## Diversified Metal Fabricators Service Bulletin SB 2078

<b>Title</b>	RW-1016 Suspension Arm Pin Hardware
<b>Document No.</b>	SB2078 Rev B
<b>Issue Date</b>	06/18/2020 (TAM)
<b>Release</b>	General
<b>Units Affected</b>	RW-1016 models (front and rear) with S/N's <u>lower than</u> 47000
<b>Purpose</b>	Reduced potential for suspension separation

**Figure 1. RW-1016 Suspension Arm Pin Hardware**

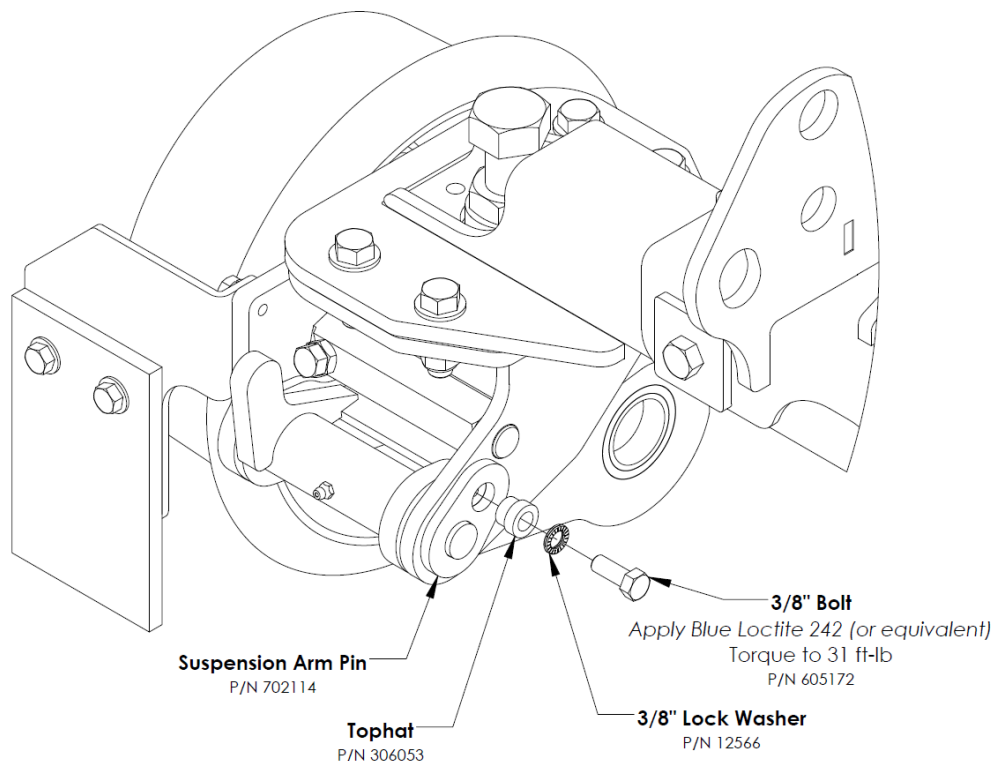
In rare circumstances, the bolt retaining the suspension arm pin may loosen and fall out over time. This may allow the suspension pin to back out, and the lower suspension arm and wheel to separate from the railgear assembly. Customers are urged to inspect these pins and their retaining hardware, and apply a "blue" medium strength threadlocking compound to their retaining bolts.

*Prior versions of this service bulletin reference replacing spring lock washers with Nord-Lock washers. The addition of threadlocking compound is recommended regardless of the type of lock washer used. Units assembled with spring lock washers or Nord-Locks can continue to use the existing hardware on the truck.*

1. Remove the 3/8" bolt retaining the suspension arm pin.
2. Apply a "blue" medium grade threadlocking compound to the 3/8" bolts (Loctite 242 or equivalent).
3. Reinstall 3/8" bolts, tophats, and lockwashers and torque to 31 ft-lb.
4. Repeat procedure on all RW-1016 suspension assemblies on vehicle.
